Brewster Wind Farm

Appendix B – Environmental Noise Assessment Audit

Verification Report

*of the
Brewster Wind Energy Facility
Pre- Construction Noise Assessment
July 2024*

Figure 1: Planning Scheme (nearest high noise amenity zoned areas); (nearest WTG >3km)

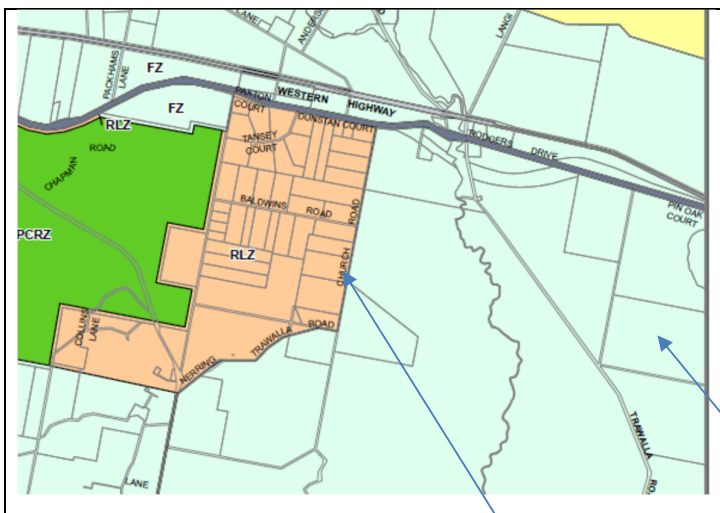
It is noted that a number of noise-sensitive locations to the west are located in other zones i.e. Rural Living (refer Figure 1). The Cherry Tree Wind Farm VCAT decision does not advise on these zones but the recent Planning Panel decision for the Golden Plains Wind Farm indicated that similar zoning is likely to be of 'High Amenity' (i.e. '*... zoned Township Zone and Low Density Residential Zone are a high amenity for the purposes of the Standard*' (ref PA1700266, 29 April 2019).

Therefore the Rural Living zone situated approximately 3.5 km from the nearest turbine to the west are potential high noise amenity areas (refer Figure 1).

A conservative approach has been adopted and a limit of 35 dB LA90 has been assessed against for compliance purposes at noise sensitive locations in this zone. All NSL's fall outside the predicted 30 dBA(A) mapped contour. The predictions are made at maximum SPL where hub height wind speeds are at and above 9 m/sec, well above the 6 m/sec maximum applicable wind speed specified on the EPA web site. Therefore at wind speeds applicable to high amenity noise conditions, levels will be even lower. Modelling therefore predicts compliance against a possible high amenity limit within the Rural Living zone area.

Figure 2: Predicted noise contours (from Figure 1 MDA, 2024)

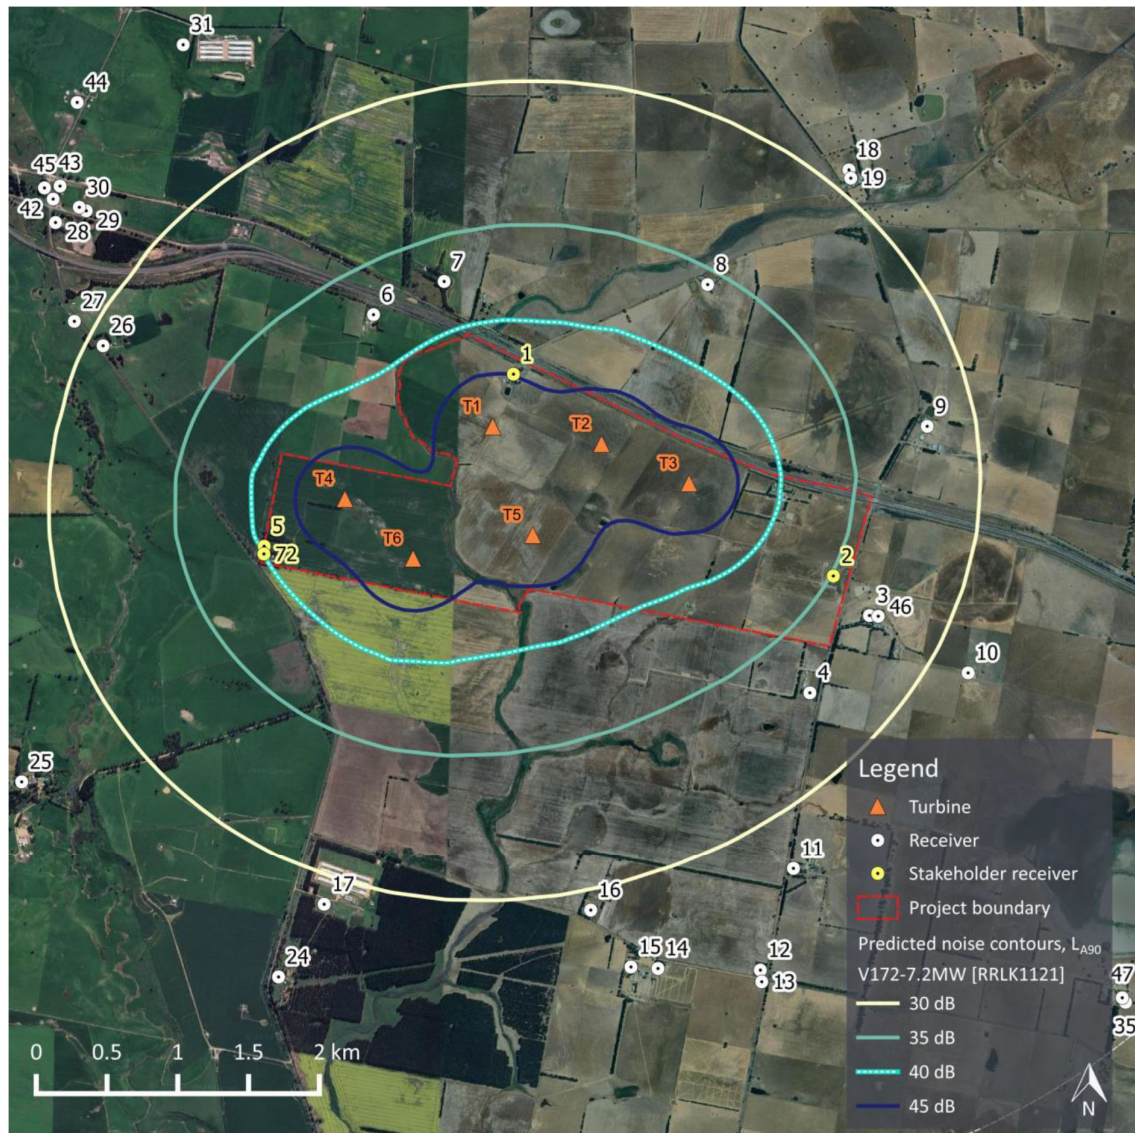
A map of the proposed turbine locations with predicted noise contours for the candidate turbine and consideration of cumulative impact from the adjoining WEFs, the nearest being the Stockyard Hill wind energy facility, has been taken from the subject report and reproduced in Figure 2.

The WEF covers a relatively small area with three (3) non-stakeholder NSL’s falling within the predicted 35 dB L_{A90} to 40 dB L_{A90} noise contours (refer Figure 2). The nearest turbine to a non-stakeholder NSL is assessed to be over 1.0 km (i.e. NSL #6).
